Response to Clarification of Further Information PA.Reg.Ref.SD22A/0460

Unit 1, M50 Business Park

June 2023

Figure 1: Site plan with vehicle access routes shown

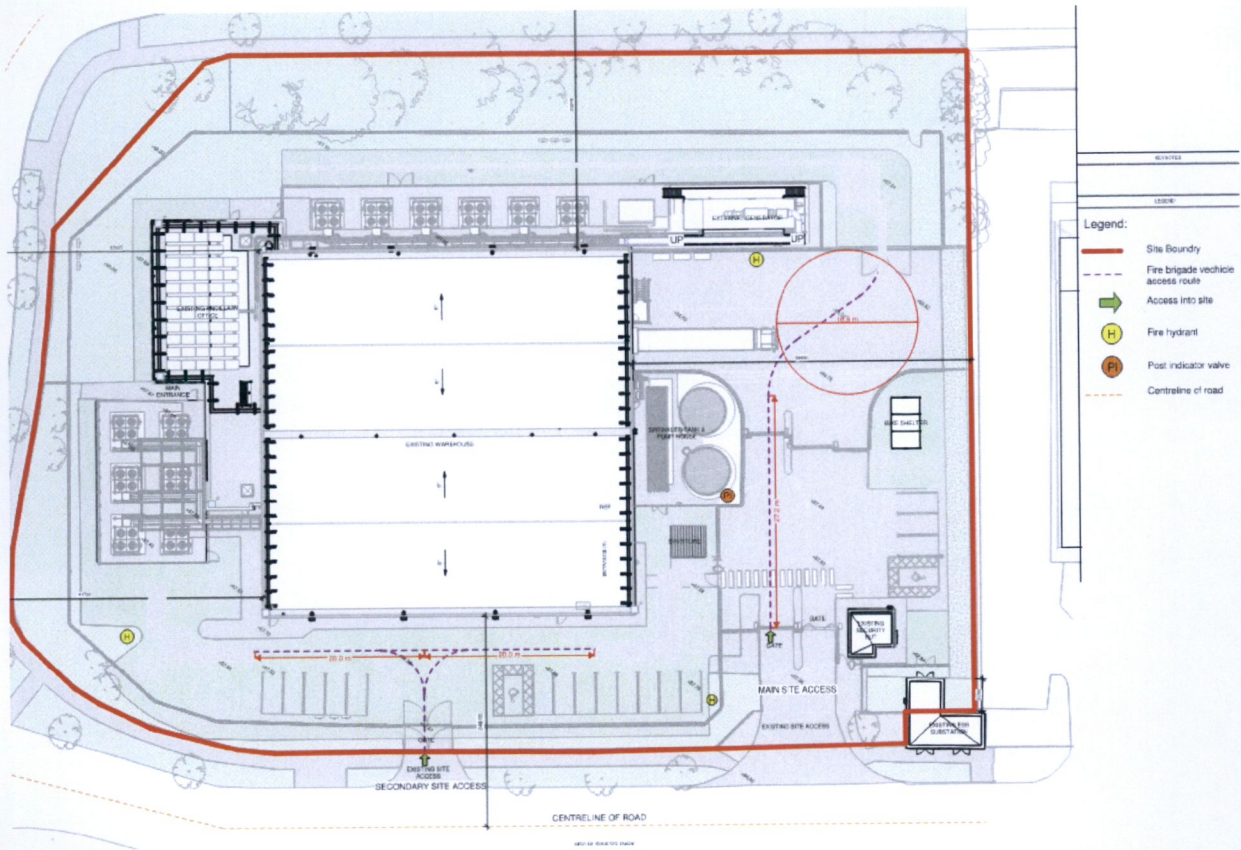
- 2) (i) **The applicant is required to submit, for verification and record purposes, the specific advice given to them by their Fire Consultant, which details why vehicle access it not required to the north of the building.**

Vehicle access to the building is provided in accordance with Table 5.1 of Technical Guidance Document B, as detailed in Table 1 below:

Volume of Building (m3)	Height of Top Storey (m)	Basis for Vehicle Access	Minimum Vehicle Access Required (m)	Vehicle Access Provided (m)	Type of Appliance
19,130 (<28,000)	4.5	15% of perimeter	31	67.2	Pump

Figure 1 below graphically represents the fire tender access provided to the building.

The vehicle access to these elevations and the associated access road will be in accordance with Table 5.2 of TGD-B for a pump appliance, as detailed in Table 2 below.

Minimum Width of Road Between Kerbs (m)	Minimum width of Gateways Between Kerbs (m)	Minimum Turning Circle Between Kerbs (m)	Minimum Turning Circle Between Walls (m)	Minimum Clearance Height (m)	Minimum Carrying Capacity (tonnes)
3.7	3.1	16.8	19.2	3.7	12.5
